Subject: UniStar Nuclear Energy, NRC Docket No. 52-016
Response to Request for Additional Information for the
Calvert Cliffs Nuclear Power Plant, Unit 3,
RAI 219, Response to Questions 02.05.01-63 through 65,
Basic Geologic and Seismic Information

Response to NRC RAI 219, Questions 02.05.01-63, 64 and 65,

Calvert Cliffs Nuclear Power Plant Unit 3

Figure 2.5-301 {Field and Aerial Reconnaissance Map for CCNPP Unit 3}

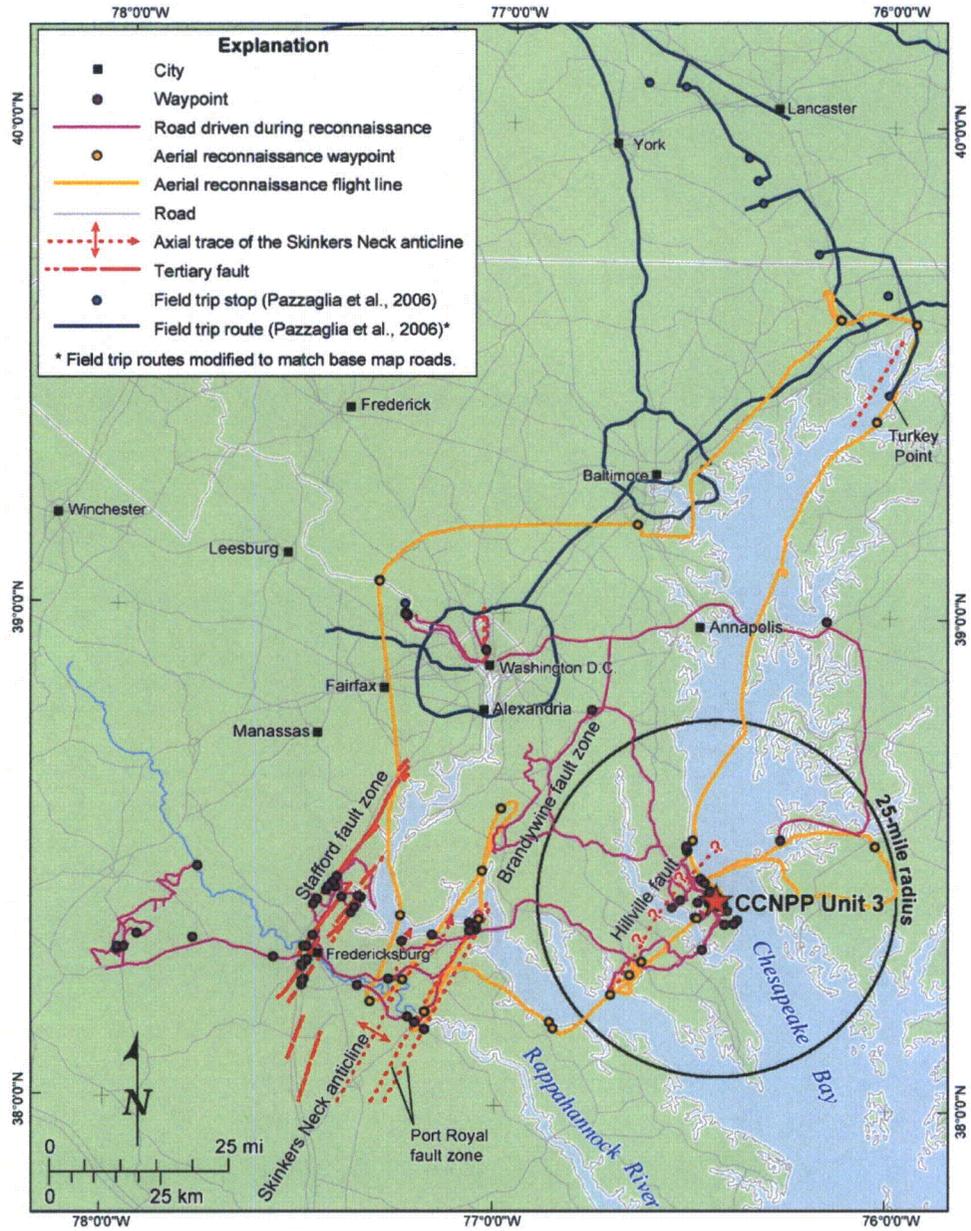
FSAR Section 2.5.1.1.4, Regional Tectonic Setting, cites the Crone and Wheeler compiled database of Quaternary structures or features with potential seismogenic properties as the basis for the statement that there is no evidence for late Cenozoic seismogenic activity on any feature in the CCNPP region. In response to RAI 02.05.01-4 the applicant provided a detailed process of what they did to evaluate potential Quaternary faults and features near the site beyond the scope of the Crone and Wheeler compilation. The applicant described a multistep process that included: compilation and review of existing published and unpublished literature; phone and in-person interviews of regional and local experts (they provided a specific list of scientists); field and aerial reconnaissance, and review of aerial photography (5-mile radius), digital elevation maps, and LiDAR coverage.

Since Crone (2000) and Wheeler (2005) did not do the detailed field work described in the RAI response to evaluate the Quaternary features near the site, please explain why a summary of this important response is not planned to be integrated into a future revision of the FSAR.

The FSAR will be revised to include a detailed description of the methodology for assessing potential Quaternary faults or tectonic features (described in response to RAI 71, Question 02.05.01-4) and a new figure showing the extent of the field and aerial reconnaissance performed for the CCNPP Unit 3 site COLA.

(3) To independently evaluate the information collected through the literature searches and interviews, UniStar conducted field reconnaissance of: (a) previously mapped geologic features and potential seismic sources within a 200-mi-radius of the site (e.g., Crone, 2000; Wheeler, 2005; Wheeler 2006), (b) site vicinity geomorphology and Quaternary geology with respect to neotectonic deformation, and (c) local cliff exposures for evidence of faulting and/or folding. Reconnaissance of key potential structures was conducted during and after consultation with local experts and literature review. Field reconnaissance was performed on the Stafford, Brandywine, Port Royal, Skinkers Neck, Mountain Run, Hazel Run, Fall Hill, Dumfries, Fall Line, Upper Marlboro, and Hillville fault zones. Field reviews of faults were followed by aerial reconnaissance. Dr. David Powars of the U.S. Geological Survey provided UniStar geologists with a tour of the Rock Creek fault zone and recent exposures of ancient gravels at the National Cathedral. The location of field stops and the aerial reconnaissance flight path are shown on Figure 2.5-301. UniStar geologists performed reconnaissance of several hypothesized faults/folds (Hansen, 1978; Kidwell, 1997; McCartan et al., 1995, and Pazzaglia, 1993) that were not evaluated by Crone (2000) or Wheeler (2005) or Wheeler (2006). UniStar geologists attended a three-day field trip affiliated with the Geological Society of America (Philadelphia, 2006) and lead by Dr. Frank Pazzaglia entitled: Rivers, glaciers, landscape evolution, and active tectonics of the central Appalachians, Pennsylvania and Maryland (Pazzaglia et al., 2006). The field trip was attended by a diverse group of geologists and geomorphologists. The trip afforded UniStar geologists the opportunity to engage with other regional experts on questions pertaining to the Quaternary and structural geology and tectonic framework of the Chesapeake Bay region (a portion of the field trip route is depicted in Figure 2.5-301).

(4) Previously mapped structures and tectonic-related geomorphology were evaluated utilizing aerial photography within a 5-mi-radius of the site and LiDAR data that encompassed St Mary's, Charles, and Calvert Counties, Maryland (a map depicting some of the LiDAR reviewed is provided in Figure 2.5-26). Multiple flights of fluvial terraces mapped previously by McCartan (1989a and 1989b) were evaluated where the Hillville and inferred Kidwell faults would project across fluvial surfaces of the Patuxent and Potomac Rivers. Lastly, aerial reconnaissance of many of the structures listed above was performed to assess their geomorphic expression and lateral continuity, if any (Figure 2.5-301).

The following new Figure 2.5-301 is added:

Figure 2.5-10—(Map of Mesozoic Basins)

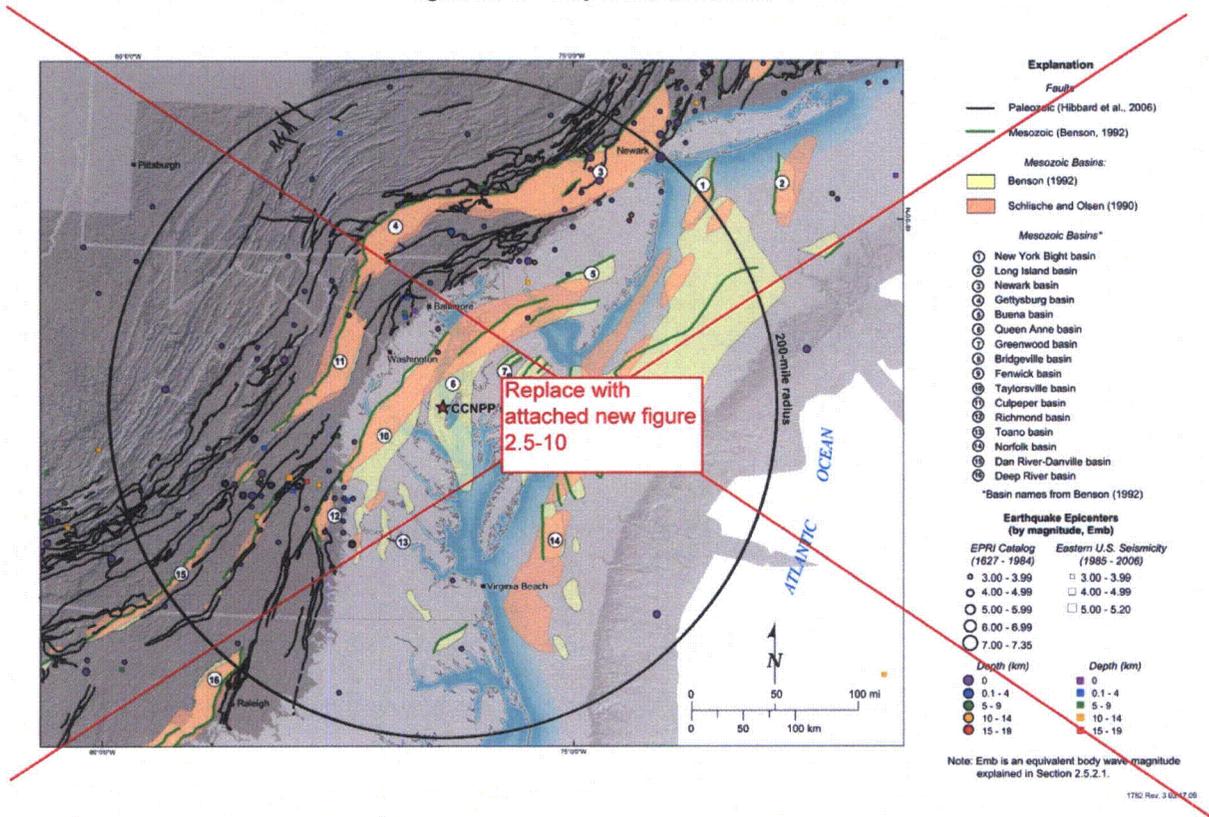
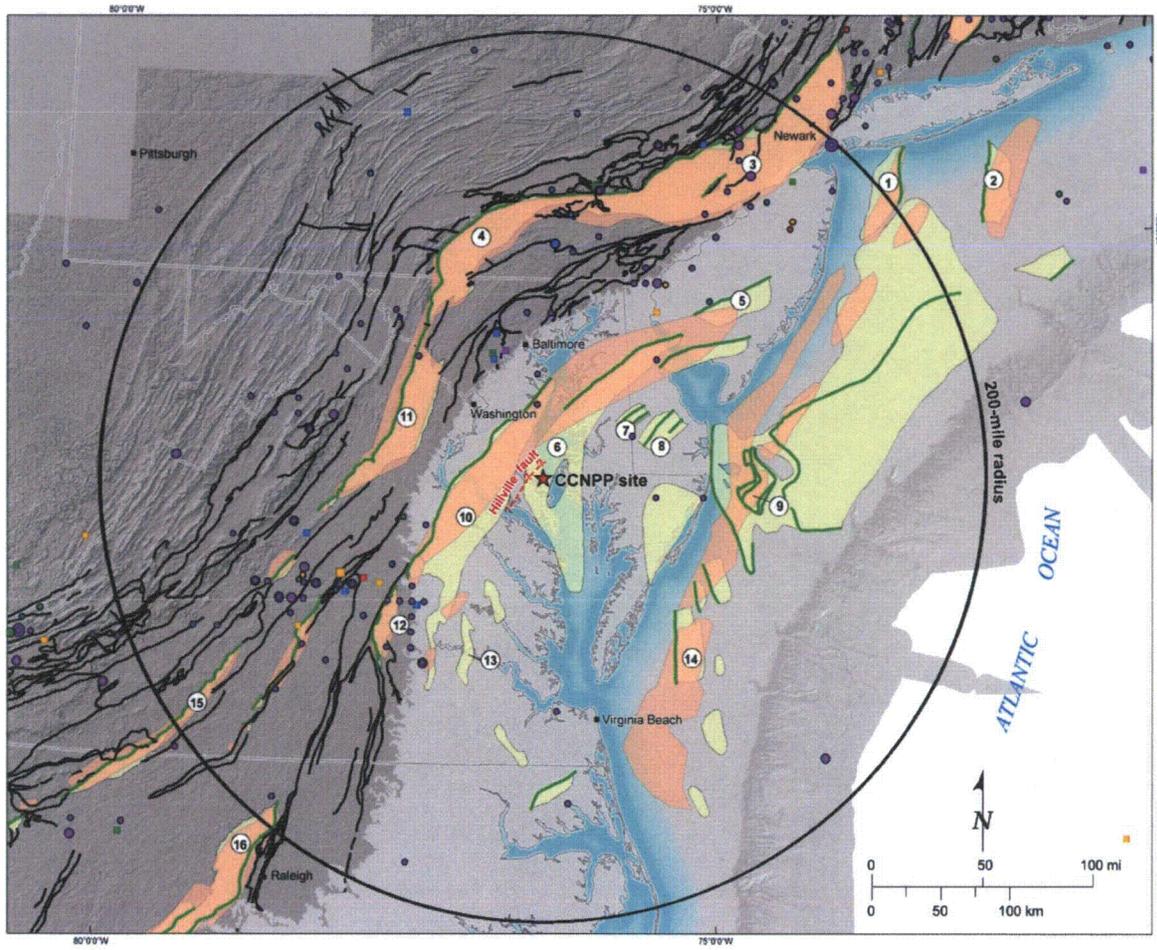
In FSAR Section 2.5.1.1.4.4.3, Mesozoic Tectonic Structures, you stated that there is no association of specific Mz basin bounding faults with demonstrable, associated seismicity or evidence of recent fault activity. In RAI 02.05.01-17 the NRC staff asked the applicant to provide a combined map of basins, boundary faults and depth coded epicenters to justify this assertion. The applicant provided a revised figure and stated that this illustrates that there is a low level of seismic activity within the 200 mile radius of CCNPP and the pattern of seismicity (earthquake magnitude, distribution and depth) is similar to the early EPRI distribution/catalog. No new large EQ associated with Mz basins are in the CCNPP region.

NRC staff notes that the revised figure shows epicenters clustered SE of traces of the Newark and Richmond basins northwestern boundary faults. In addition, the revised figure provided by you shows zero depths for nearly all the EQs, which precludes knowing if they occurred on the MZ faults or not. Zero km is not usually taken as a fixed depth for poorly located EQs. Please discuss the accuracy of the earthquake locations with respect to the basin and basin bounding faults and implications for recent interpretations of earthquakes below the basin in Precambrian rock.

The input for response to RAI 71, Question 02.05.01-17 included a revised FSAR Figure 2.5-10. FSAR Figure 2.5-10 will be further revised in response to this question as discussed below. In the RAI 71 revision of FSAR Figure 2.5-10, a depth scale was added to the earthquakes from both the EPRI-SOG catalog and the updated catalog developed for the CCNPP Unit 3 COLA. In the updated catalog, there are 31 earthquakes within the extent of FSAR Figure 2.5-10, all of which have reported depths as shown in the figure. None of the post-EPRI earthquakes are located within the Richmond Basin, but four are located approximately 15 km east of the basin (Note: these earthquakes appear to plot on top of each other in FSAR Figure 2.5-10 due to the scale of the figure). None of the earthquakes from the updated catalog are located within the Newark basin, but 4 earthquakes are located either immediately east or west of the basin. For these earthquakes in the updated catalog, there are no formal epicentral location uncertainties reported within their parent catalog as reported by ANSS (see FSAR Subsection 2.5.2.1). However, location uncertainties for these events would have been assumed to be about 5 km under the original EPRI-SOG methodology.

In the EPRI-SOG seismicity catalog, there are 197 earthquakes within the extent of FSAR Figure 2.5-10 that have an Emb magnitude greater than or equal to 3.0. Of these earthquakes, 175 (89%) do not have reported depths. In the RAI 71 revised FSAR Figure 2.5-10, these earthquakes without depth information were plotted with a depth of 0 km. In the response to Question 02.05.01-65, FSAR Figure 2.5-10 will be revised to distinguish between zero depth earthquakes and earthquakes where no depth information is contained within the EPRI-SOG seismicity catalog. Of these 197 earthquakes, there are 13 located in or near the Richmond Basin and 19 earthquakes in or near the Newark Basin, none of which have depths within the EPRI-SOG catalog. Also, none of the earthquakes within the EPRI-SOG catalog have reported location uncertainties, but, based on the dates of their occurrence (1737 to 1980) and small size (five between Emb 4.0 and 5.1, the rest less than Emb 4.0), it is unlikely that any but the most

Despite the lack of depth constraint on the earthquakes within the EPRI-SOG catalog and the absence of epicentral uncertainty estimates within both catalogs, recent work by Sykes et al. (2008) has suggested that seismicity occurring near the Ramapo Fault (the basin-bounding fault of the Newark Basin) occurs within Proterozoic to early Paleozoic rocks in the footwall of the fault and not along the fault. This work of Sykes et al. (2008) is discussed in detail in the response to RAI 134, Question 02.05.01-61 and FSAR Subsection 2.5.1.1.4.4.5.4, but in brief Sykes et al.² used well-located seismicity from a local network near the Ramapo Fault to demonstrate that: (1) there is not an alignment of seismicity with the southeast dipping Ramapo fault in cross section (FSAR Figures 2.5-216 and 2.5-217), and (2) seismicity located west of the Ramapo fault in map view is located within the Proterozoic to early Paleozoic footwall rocks (FSAR Figures 2.5-216 and 2.5-217).

Replace the existing FSAR Figure 2.5-10 with the updated figure attached.
